Item No. 9 Subdivision and Rezoning – 963 Centennial Street
(River Heights-Fort Garry Ward)
File DASZ 34/2022 [c/r DAV 151948/2022D]

Title: DASZ 34/2022 – 963 Centennial Street

Issue: For consideration at the public hearing for a rezoning to "RMF-S" Residential Multi-Family Small to permit a townhouse development (seven units).

DATE:	March 17, 2023
FILE:	**DASZ 34/2022**
RELATED FILES:	DAV 22-151948\D
COMMUNITY:	City Centre Committee
NEIGHBOURHOOD #:	1.618 Mathers
SUBJECT:	For Consolidation and Rezoning to “RMF-S” Residential Multi-Family (Small).
LOCATION:	963 Centennial St
LEGAL DESCRIPTION:	LOT 3 BLOCK 13 PLAN 1538 60 ST B LOT 1 PLAN 27533 59/60 ST B

SITE / ROOF PLAN
Not to scale

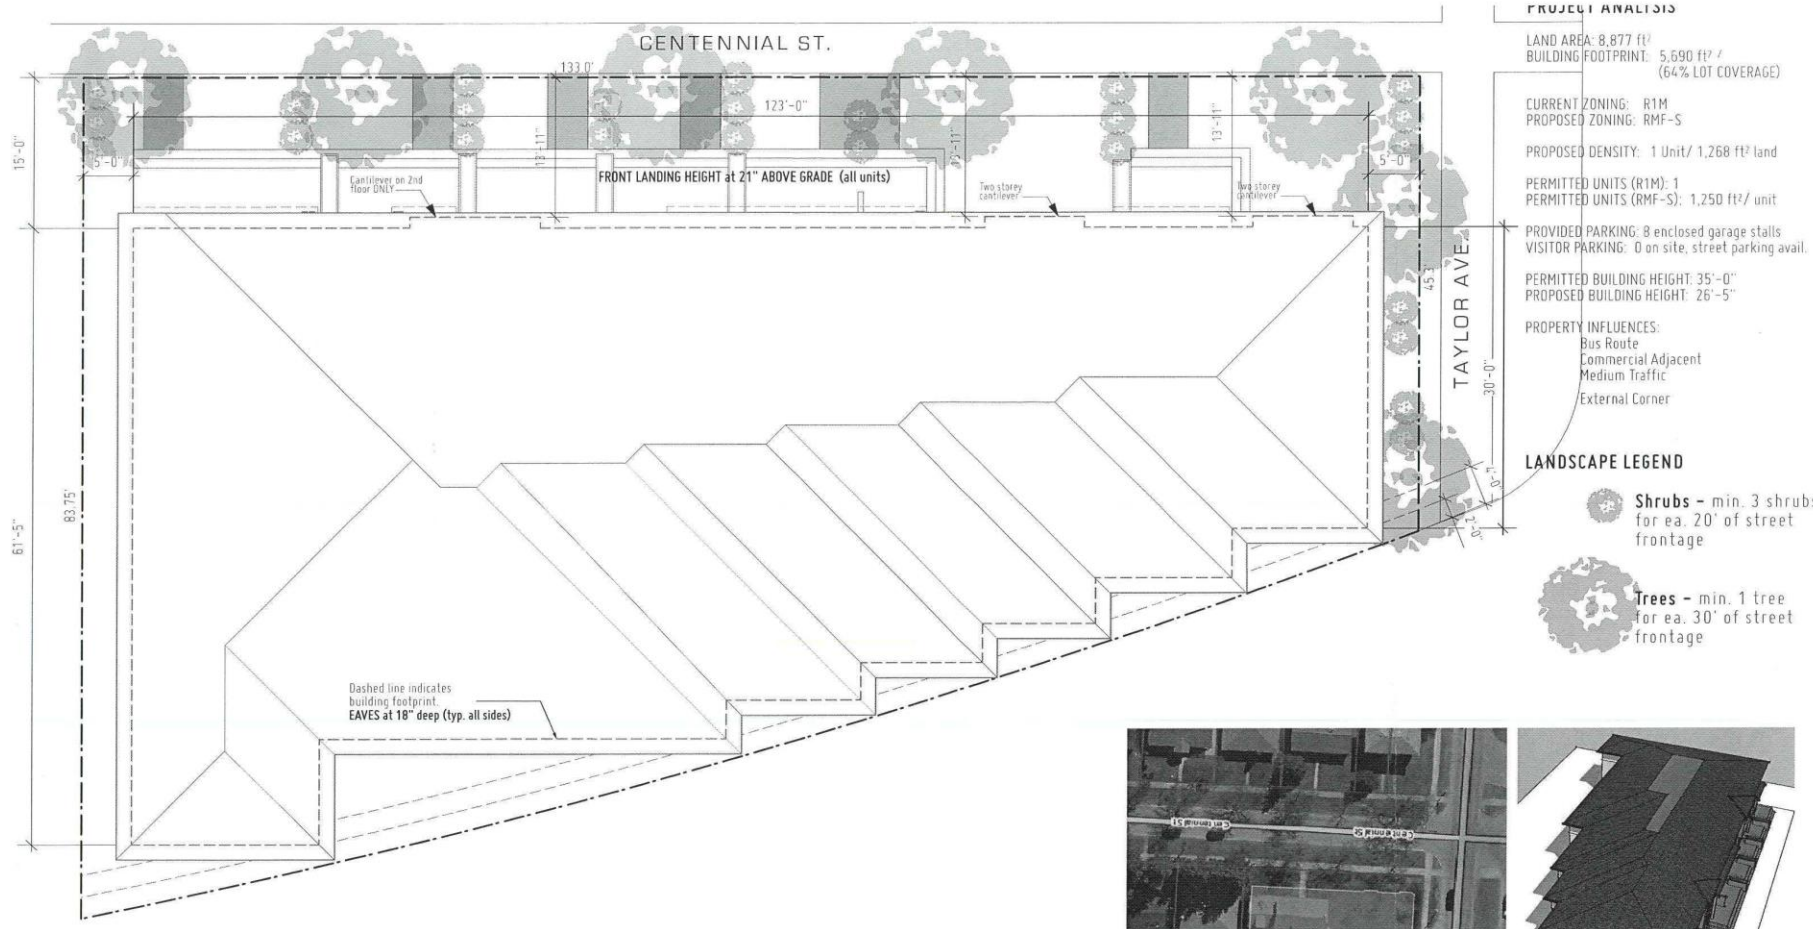
- Lot coverage: 42% permitted, 64% proposed
- Rear yard: Minimum 25 feet required, 2 feet proposed
- Front yard: 25 feet based on front yard alignment (variances permitted within 5 feet of alignment), 15 feet proposed (variance of 10 feet).

- Side yards: Minimum required side yards are 6 feet on each side, 5 feet are provided on each side.
- Corner façade condition: Required window coverage on elevation flanking Taylor Avenue is 15%, 7.2% is proposed. A unit facing the corner street is strongly encouraged.

- One-storey projections into front yard: For a stoop or porch may extend into the required front yard setback 5 feet, but not less than 10 feet from the property line. It appears they are 6-7 feet from the property line. Dimension not shown.

- Soft landscaping: Percentage of coverage is unknown. 20% is required.
- Trees: Required to be planted not less than 6.56 feet (2.0 metres) from a public sidewalk, a minimum of 3.28 feet (1.0 metres) from a property line, and should be located at a sufficient distance from the dwelling to allow for full canopy and root system development. The proposed trees appear to be shown less than 5 feet from sidewalks on Centennial Street and Taylor Avenue.

The plans show major inconsistencies with the design guidelines and as such, a context-sensitive townhouse development has not been demonstrated at this time.
